International Code Council

A117.1 – 2017 edition

**Public proposals received
On the first public review draft**

2023 A117.1 proposal list

Figure 802.5.1(A) Wheelchair Space Location Overlap - Rear Approach - ~~New and Existing Buildings~~

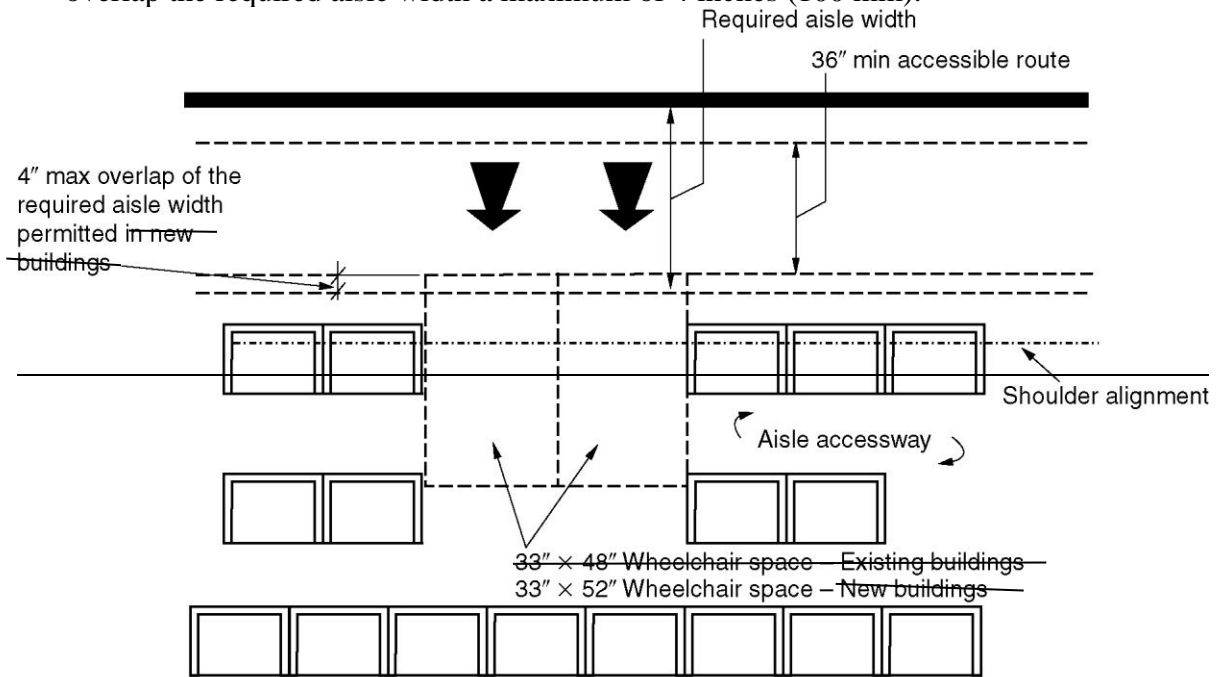
802.5.1 Overlap. ~~A~~ The width of a wheelchair space shall not overlap the required width of an aisle.

~~Exception:~~ In new buildings, the ~~The~~ depth of a wheelchair space shall ~~be permitted to~~ overlap the required aisle width a maximum of 4 inches (100 mm).

Proposed overlap allowance

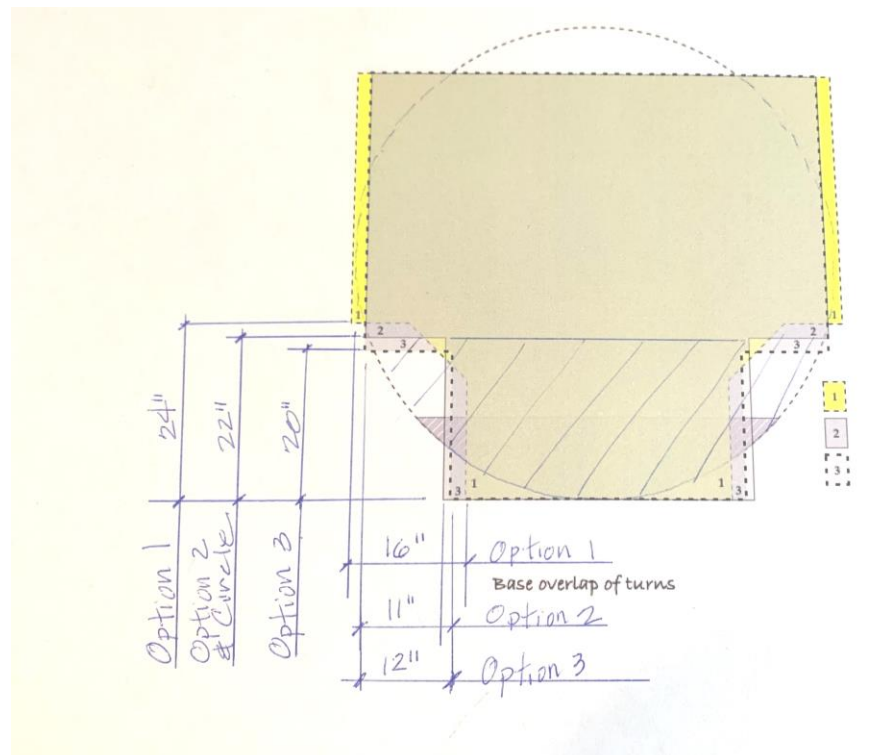
REASON: The purpose of this proposal is to coordinate the overlap allowances for turning spaces. The A117.1 decided not to change the knee and toe clearances between the 2009 and 2017 edition. The turning spaces have increased in size and substantially limited the overlap at the same time. Since the circle and T-turn are to turn 180 degrees, they should be consistent – while now there are substantial differences in all 4 options. With the larger turning space, these proposals will still be a reduction on the total percentage of the turning space permitted under the

FIGURE 407.2.1.7
DESTINATION-ORIENTED ELEVATOR INDICATION

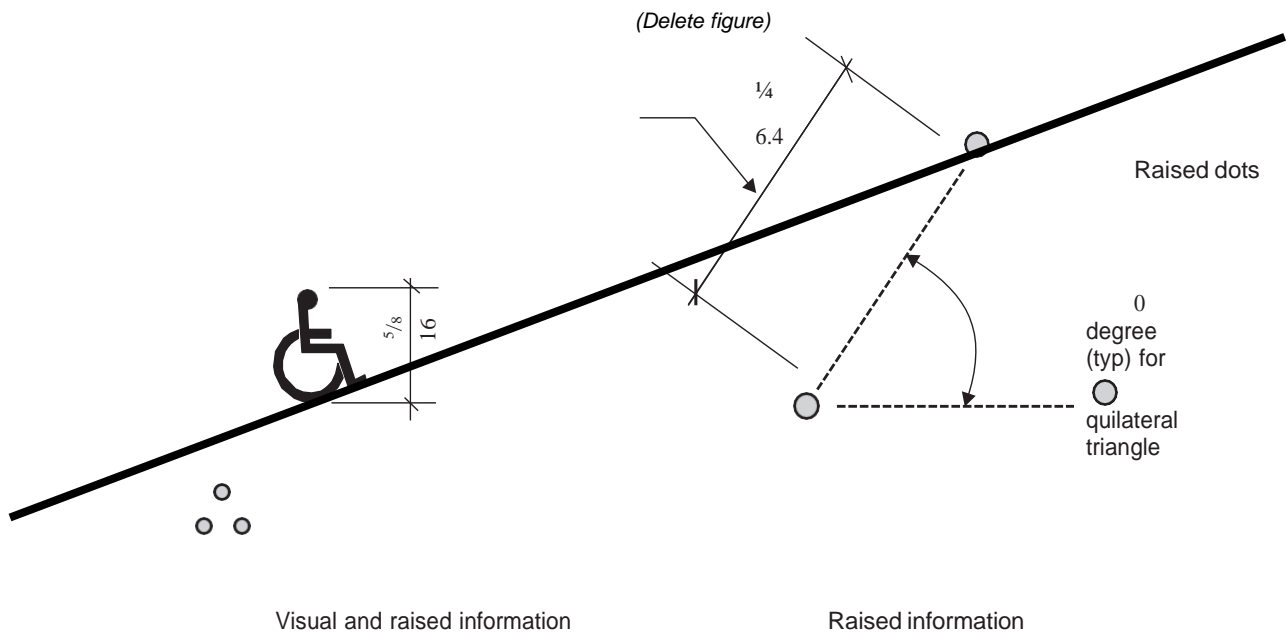
~~407.2.1.7 Destination-oriented elevator signals.~~ Destination-oriented elevators shall be provided with a visible signal and audible tones and verbal announcements to indicate which car is responding to a call. The audible tone and verbal announcement shall be activated by pressing a function button. The function button shall be identified by the International Symbol for Accessibility and a raised indication. The International Symbol for Accessibility, complying with Section 703.6.3.1, shall be $\frac{5}{8}$ inch (16 mm) in height and be a visual character complying with Section 703.2. The indication shall be three raised dots, spaced $\frac{1}{4}$ inch (6.4 mm) at base diameter, in the form of an equilateral triangle. The function button shall be located immediately below the keypad arrangement or floor buttons.

**FIGURE 502.9.1
WIDE SIDEWALKS**

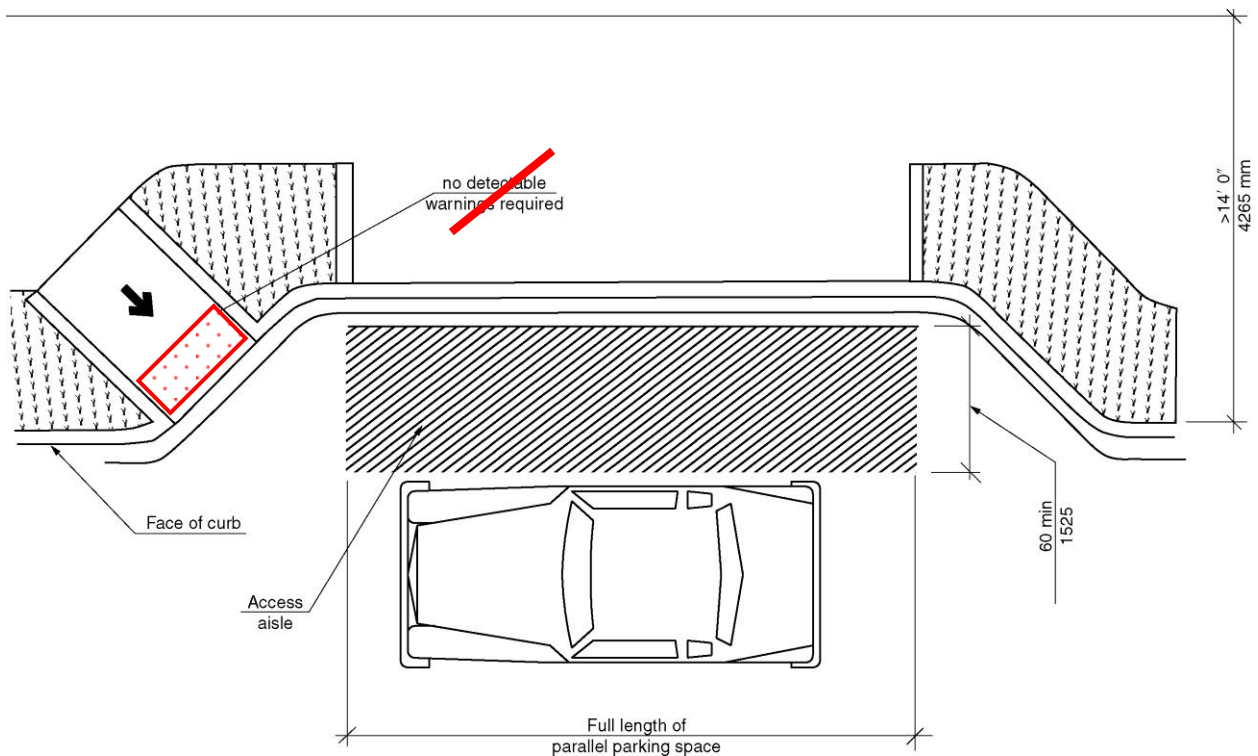
Note: The curb ramp in this figure should show detectable warnings.

REASON: Curb ramps are not complete without detectable warnings. While there is a section showing detectable warnings on curb ramps in some detail, they should not be omitted here. It implies that they are not required. Wherever curb ramps are depicted, unless they are not required to have detectable warnings, as in Figure 502.9.1, the detectable warning should be included. Figure 502.9.1.2 correctly includes the detectable warning, even though it is in Section 502 Parking Spaces.

**FIGURE 503.3(A)
PASSENGER LOADING ZONE ACCESS AISLE - NEW BUILDINGS**

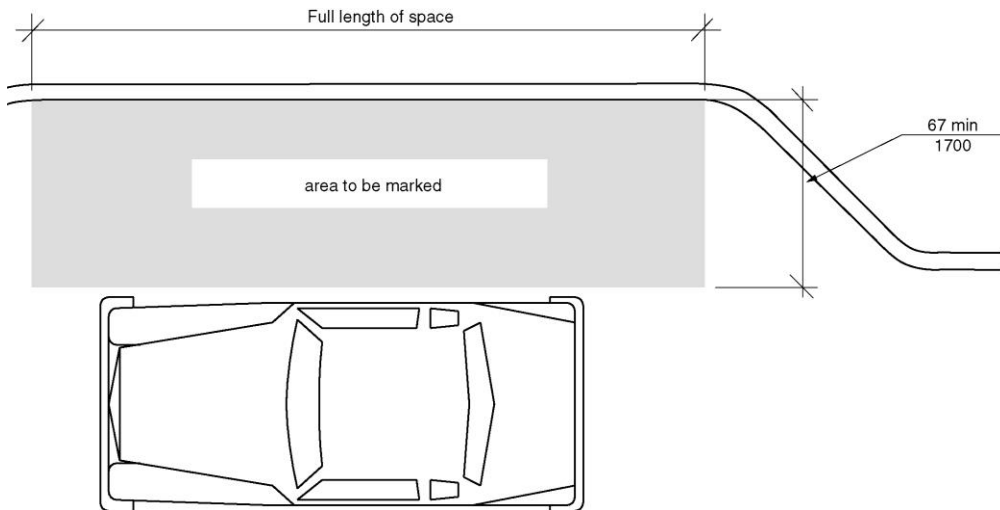
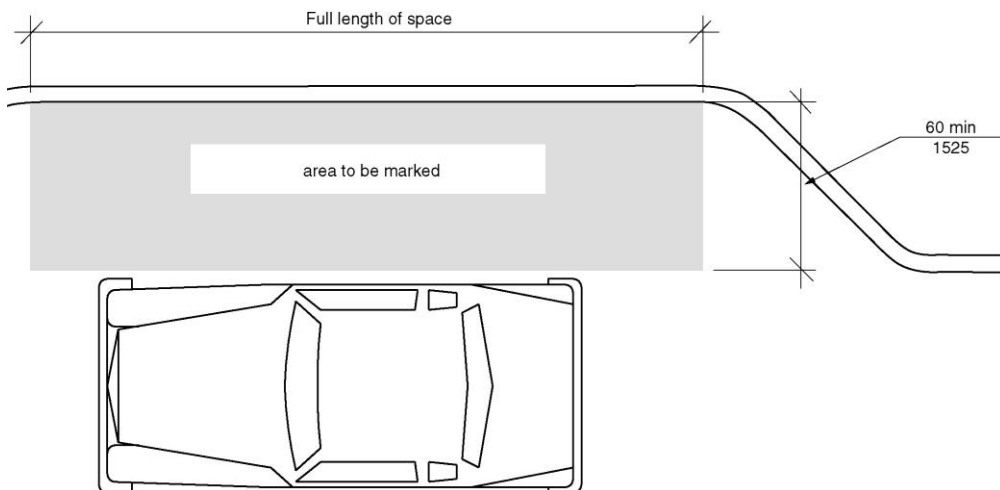
Note: Add curb ramps

Examples of stairway markings in new exception.

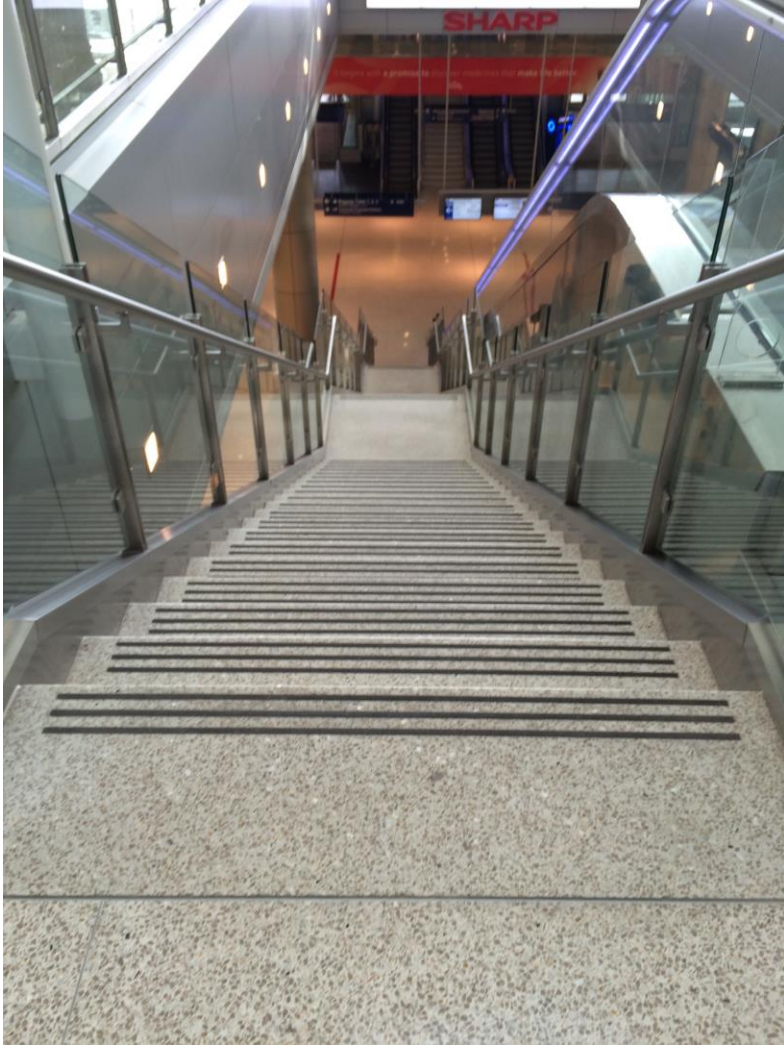
REASON: The intent of this proposal is to provide an alternative for marking stairways. Section 504.6 added an Item 2 to remove the conflict between the A117.1 stairway provisions and where stairways required warning markings are required in IBC. However, not all stairways are required to be marked in IBC. The A117.1 significantly improved the lighting on stairways. This is also in the 2021 IBC Section 1008.2.1. This was recommended as a means to notify visually impaired persons of the change in level to stairways. A stripe at each step is not needed since stairway safety studies indicate muscle memory put as person into a stairway gait in only two steps. See the examples for the new proposed Item 2 and the current Item 1.

This seems to provide a clearer message than steps that could comply with the current exception 1.

Figure 604.9.3(B)
Wheelchair Toilet Compartment Doors
Exception 3 – Alternate Wheelchair Compartment

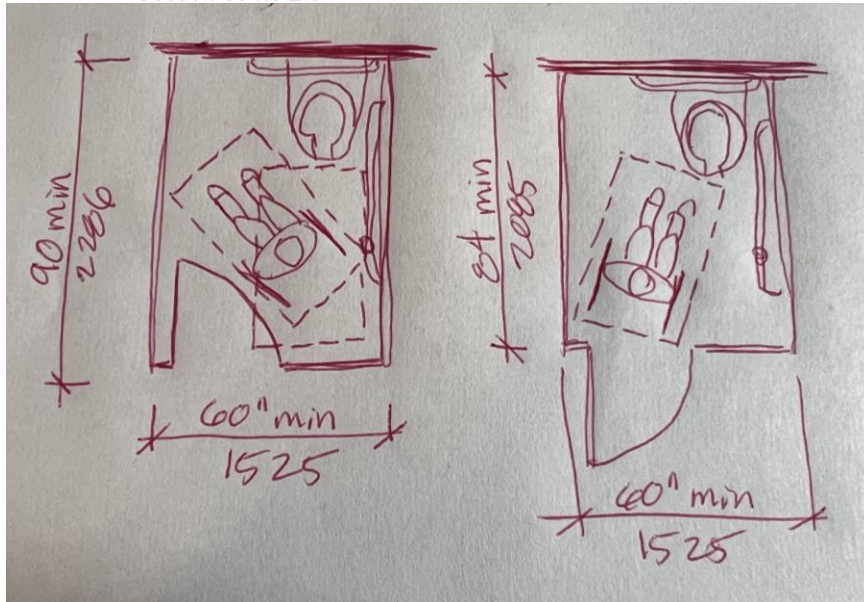
This proposal ties and limits the third exception directly to the alternate compartment provisions of Section 604.9.2.3 and ensures that the door is located to allow a user to move straight into the stall. Without a limitation for the door to be located in the front wall (as was the original intent), Section 604.9.3.1 could be used to allow a side wall door. Again the original proponent and the committee were expecting the door for the “alternate” compartment to be located as shown in Figure 604.9.3(B) and to allow the user to move directly into the compartment and to allow a forward approach to the water closet.

By specifically referencing Section 604.9.2.3, the exception will clearly indicate when it is permitted to be used. This will ensure the exception is limited to the compartment configuration that was intended and that it is not used for other “alternate” (atypical) designs such as what is shown in Figure 604.9.3(A). Because a code user may select and use any of the exceptions, it is important that Exception 3 be limited to the specific alternate configuration which was intended and not be applied to other configurations which were not discussed and may not adequately address maneuvering within the compartment.

Figure 607.5.1

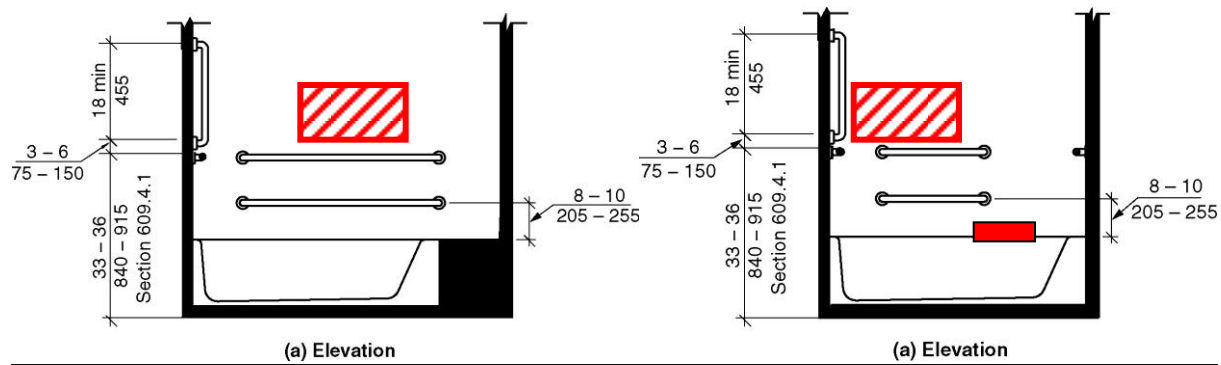
Note: Add two new figures with dimensions to match text for rear wall controls.

**FIGURE 1104.11.3.1.3.3(B)
TRANSFER-TYPE SHOWER COMPARTMENT IN TYPE B UNITS
EXCEPTION**

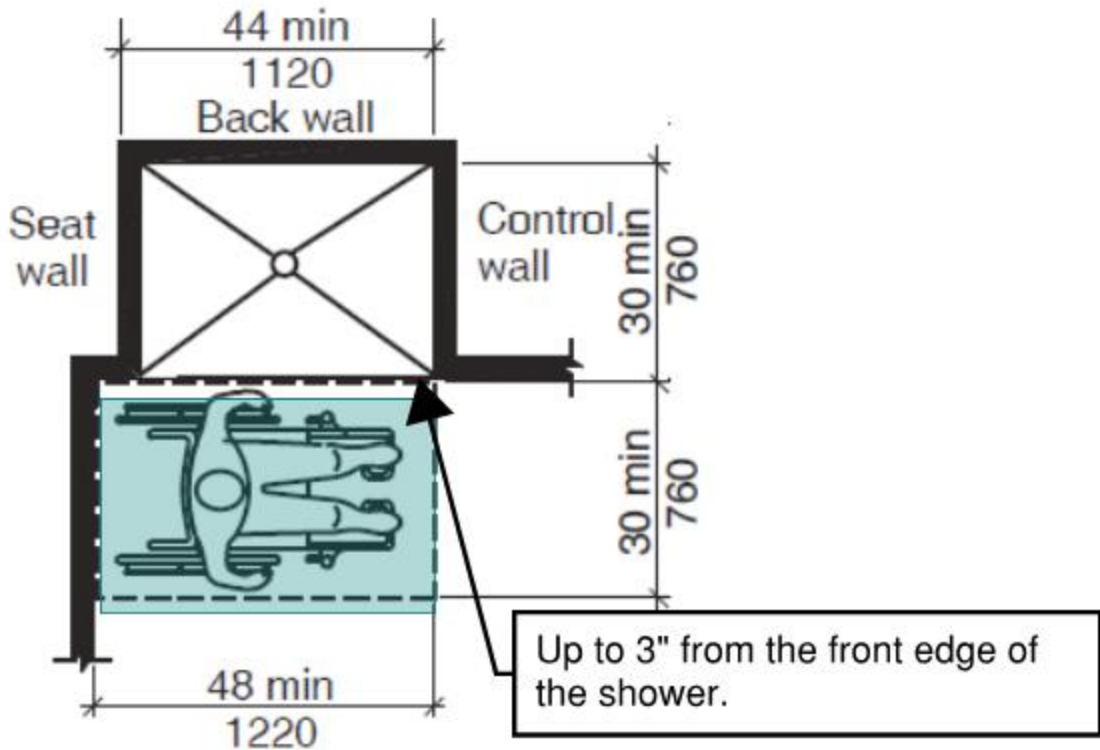
REASON: I am proposing adding language to address designs where showers may be recessed (often due to the flange installation). Especially when the shower pan is < 48", this can create a situation where the minimum 30" x minimum 48" clearance is not flush with the shower. Allowing the clearance to be up to 3" from the face of the shower, will permit the construction/flange to be installed as needed and the required clearance to be compliant. In addition, the controls will still be within accessible reach range (< 24".) See graphic below.

**FIGURE 1104.11.3.2.3.1
BATHROOM CLEARANCE IN TYPE B UNITS OPTION B BATHROOM**

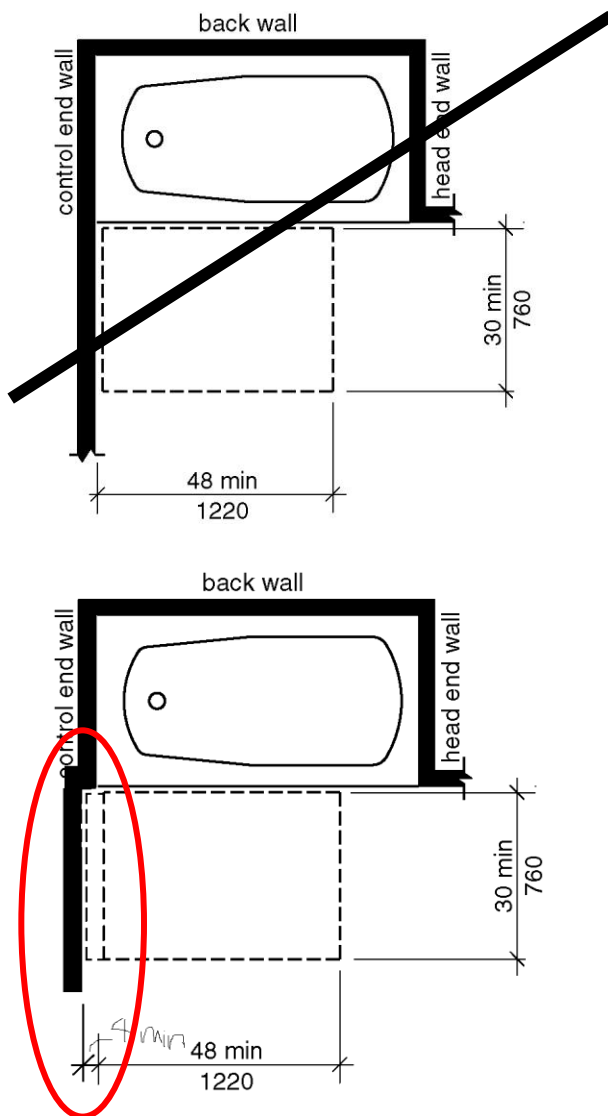
Note: Replace figure 1104.11.3.2.3.1 with the following. The figure will be revised to add the 4 inch minimum control clearance.
